PORTION OF SE QUARTER OF SEC 27, TWN 20 N, RGE. 4 E, W.M.
CITY OF PUYALLUP, PIERCE COUNTY, WASHINGTON

No.	Date	By	Ckd.	Appr.	Revision
1	12/06/23	DL	DL	JSG	RESPONSE TO CITY COMMENTS, DATED 10-06-2023

Title: COVER SHEET
CIVIL PLANS
FORTRESS - PUYALLUP

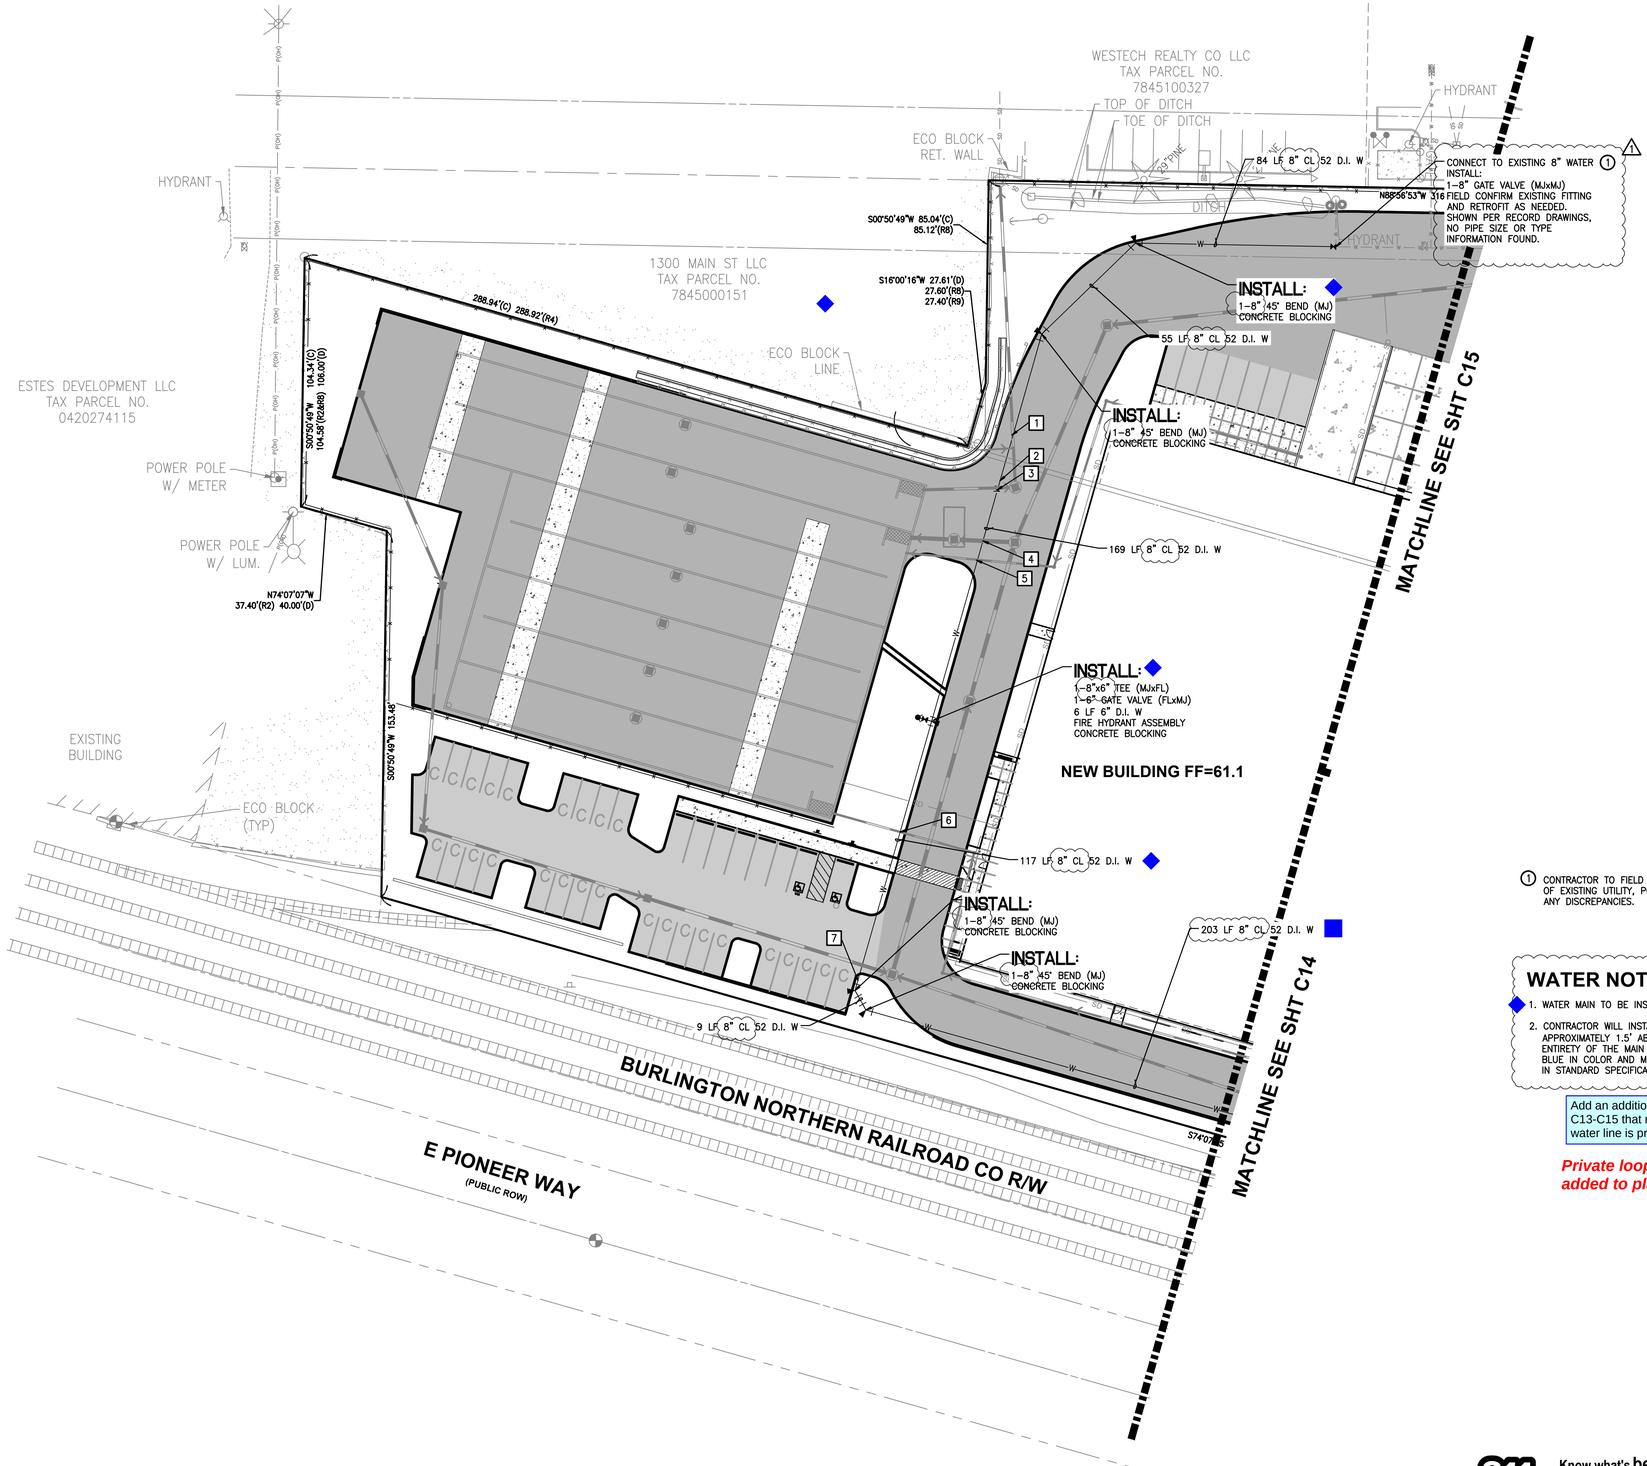
Add an additional water note on sheets C13-C15 that mentions the 8" looped water line is private. [civils, sheet C13]

Sheet C15 of 32

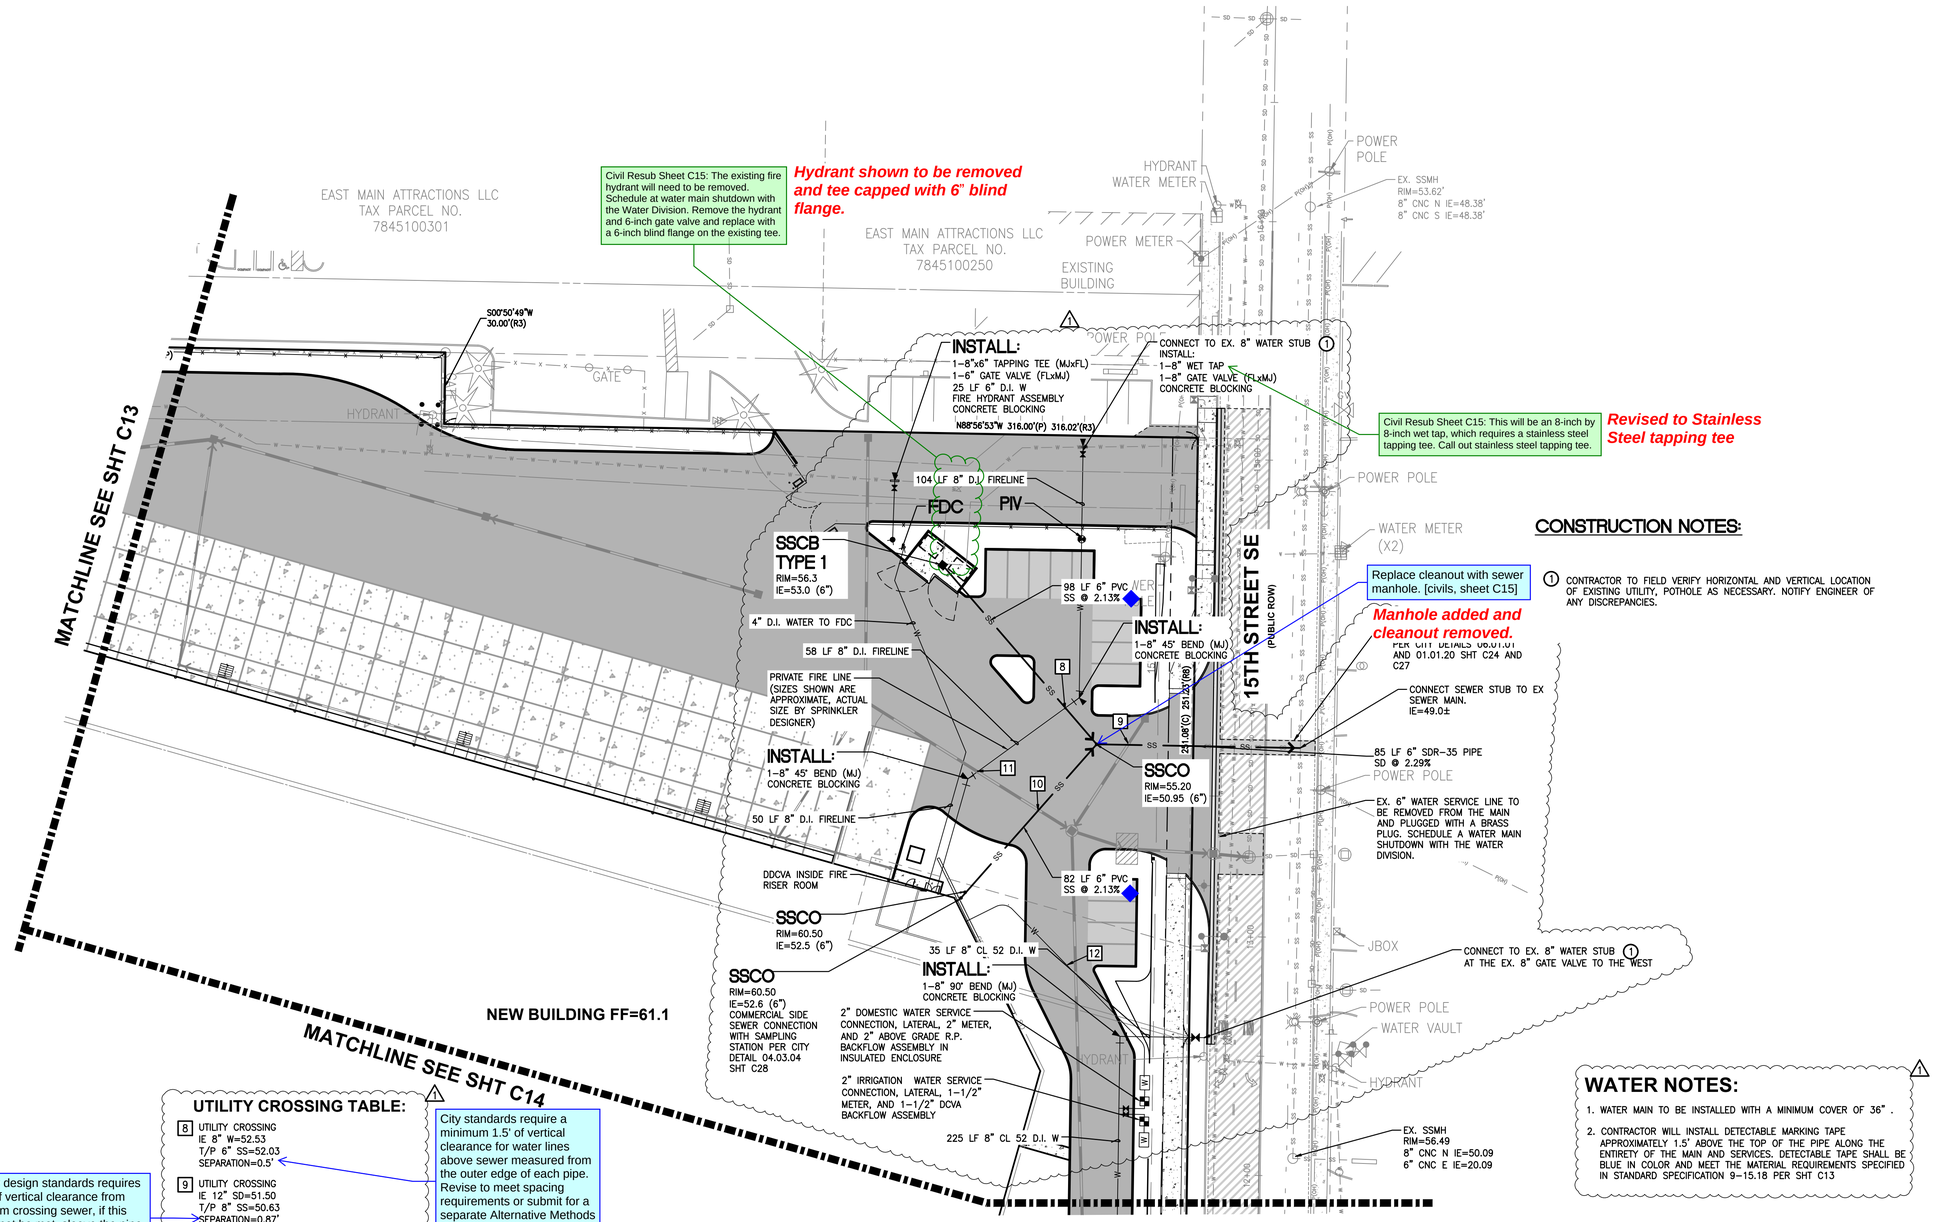
City design standards requires 1' of vertical clearance from storm crossing sewer, if this cannot be met, sleeve the pipe per city design standard 204.4(8). [civils, sheet C15]

City standards require a minimum 1.5' of vertical clearance for water lines above sewer measured from the outer edge of each pipe. Revise to meet spacing requirements or submit for a separate Alternative Methods Request via the CityView portal. [civils, sheet C15]

Sheet C16 of 32

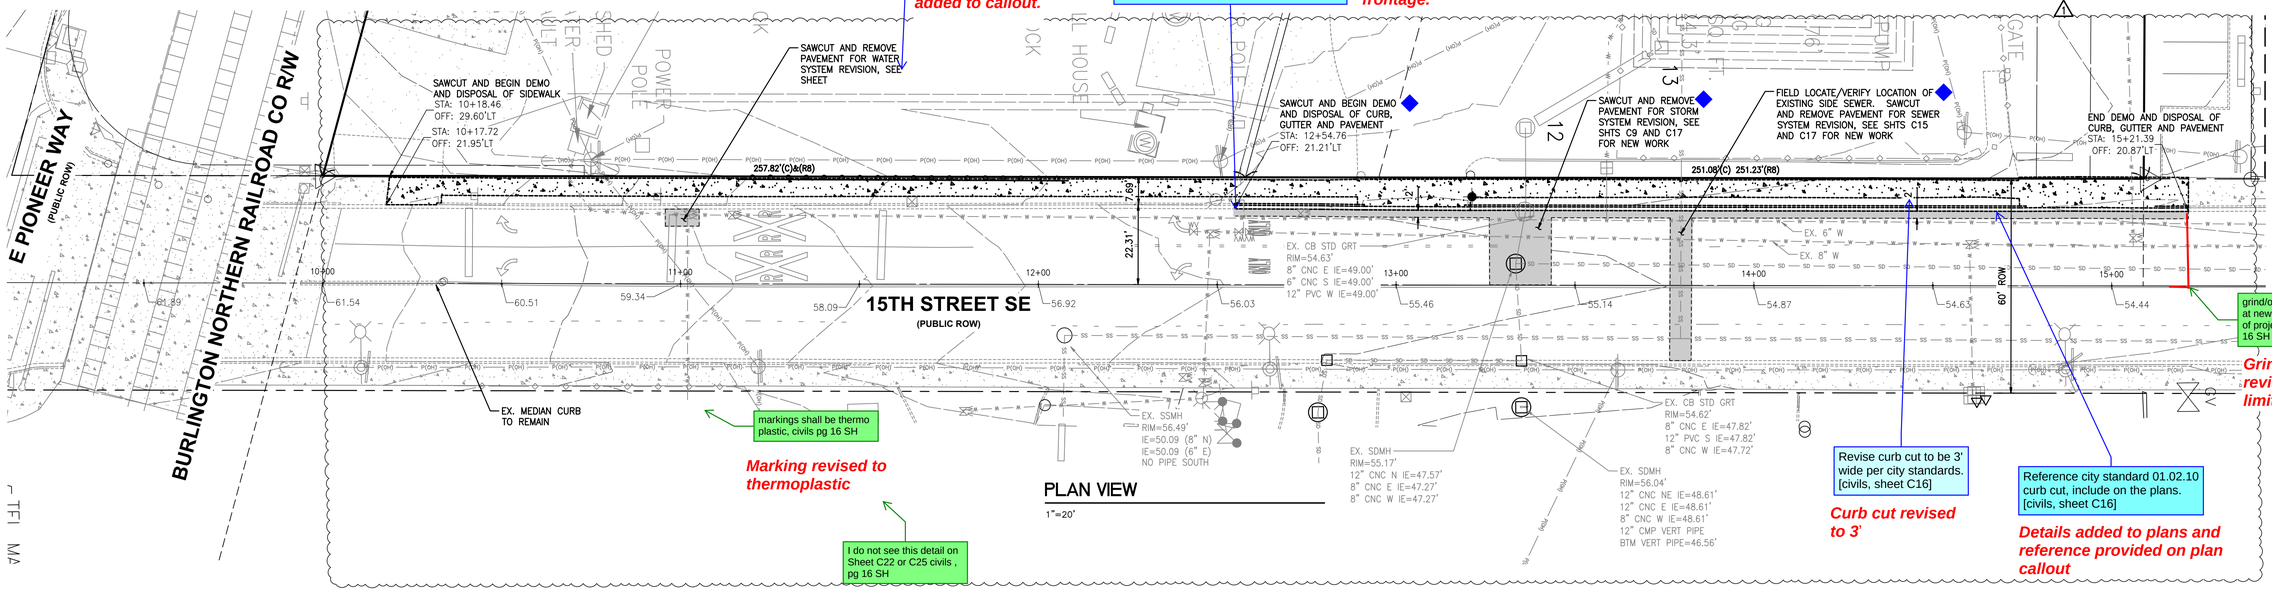
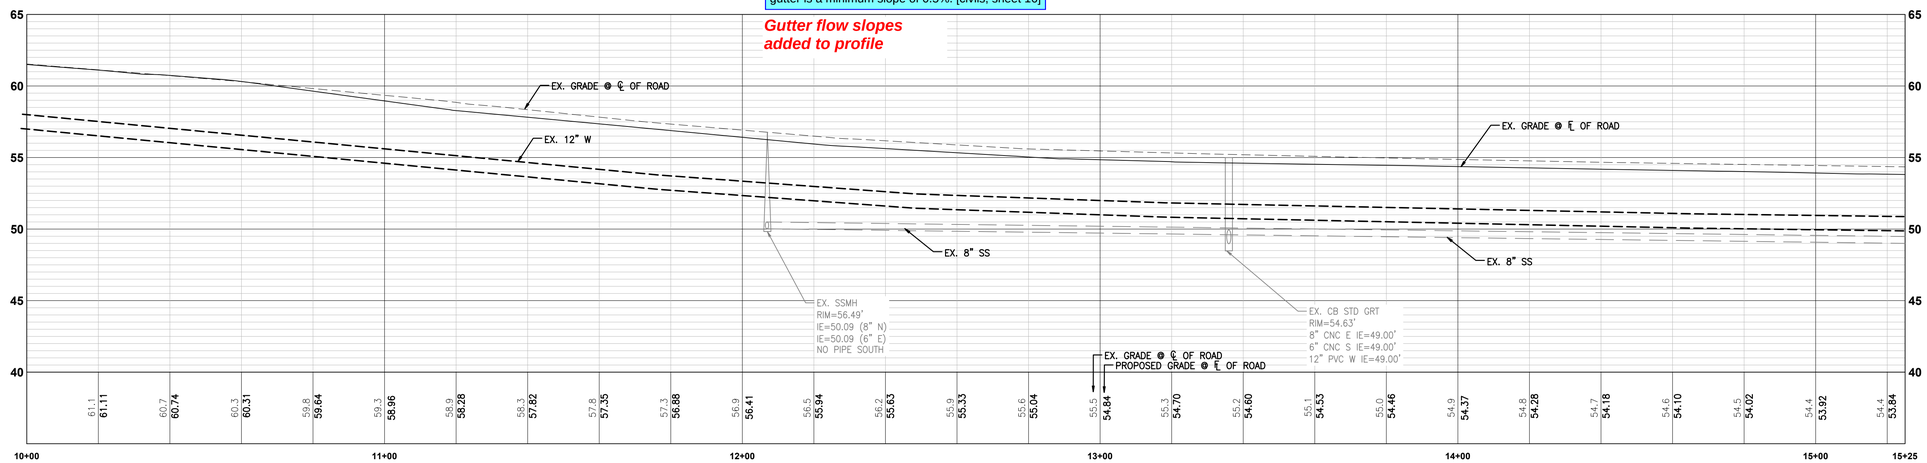
Provide sheet reference as intended. [civils, sheet C16]

Replace curb and gutter along the entire length of frontage per PMC 11.08.135. [civils, sheet C16]

markings shall be thermo plastic, civils pg 16 SH

I do not see this detail on Sheet C22 or C25 civils , pg 16 SH

Revise curb cut to be 3' wide per city standards. [civils, sheet C16]

Reference city standard 01.02.10 curb cut, include on the plans. [civils, sheet C16]

Provide the gutter flow slope, ensure the proposed gutter is a minimum slope of 0.5%. [civils, sheet 16]

Curb and gutter shown replace along entire frontage.

Gutter flow slopes added to profile

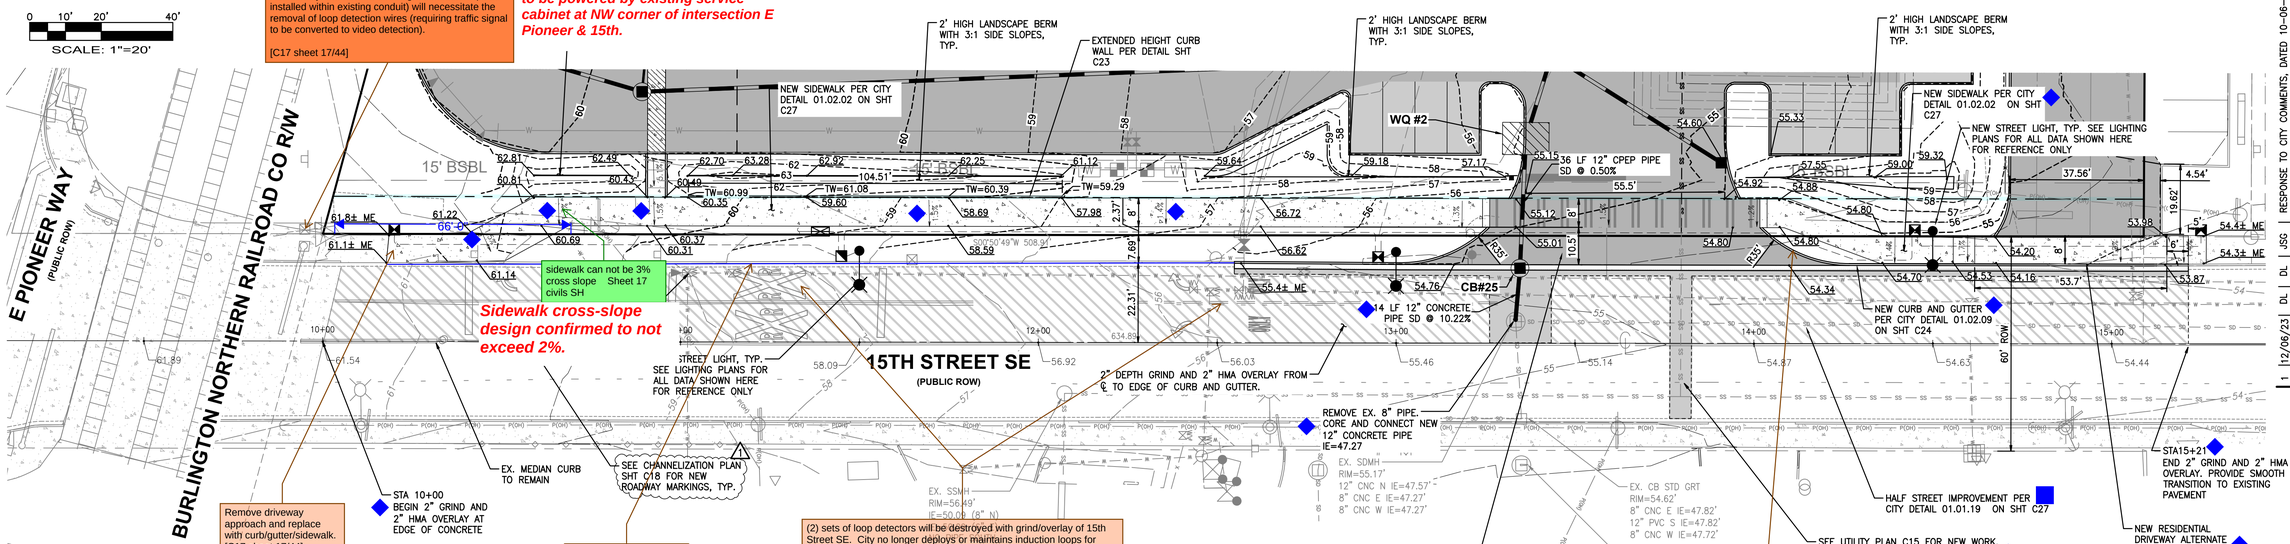
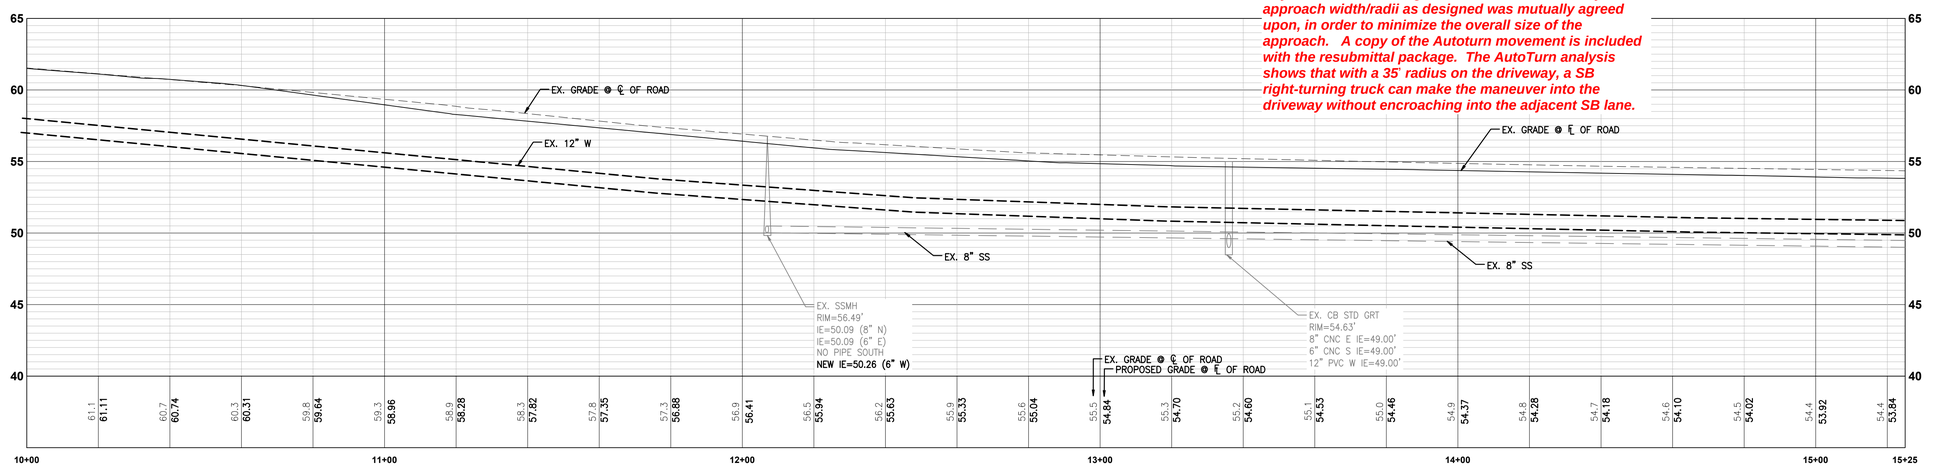
J-box contains wiring/conduit for (2) sets of loop detectors (SB approach). Streetlights shall use this existing conduit to power lights from existing service at traffic signal on the south side of RR tracks. Additionally, the new #8 streetlight conductors (to be installed within existing conduit) will necessitate the removal of loop detection wires (requiring traffic signal to be converted to video detection).
[C17 sheet 17/44]

Per previous comment, the design engineer must determine the required radius on the north side of intersection to allow inbound right trucks (SBR) to access site without encroaching into adjacent lane of (SB) traffic. Curb radii and entrance dimensions shall be increased as necessary to allow vehicles to access the site without encroachment. Provide AutoTurn analysis showing this movement.
[C17 sheet 17/44]

TENW: Comment incorporated as requested. Removed new service cabinet. New street lighting is shown to be powered by existing service cabinet at NW corner of intersection E Pioneer & 15th.

Drive approach shown removed and replaced with curb, gutter, and sidewalk.

This previous comment required a discussion with the City Staff and a re-design as a result. The driveway approach width/radii as designed was mutually agreed upon, in order to minimize the overall size of the approach. A copy of the Autoturn movement is included with the resubmittal package. The AutoTurn analysis shows that with a 35' radius on the driveway, a SB right-turning truck can make the maneuver into the driveway without encroaching into the adjacent SB lane.
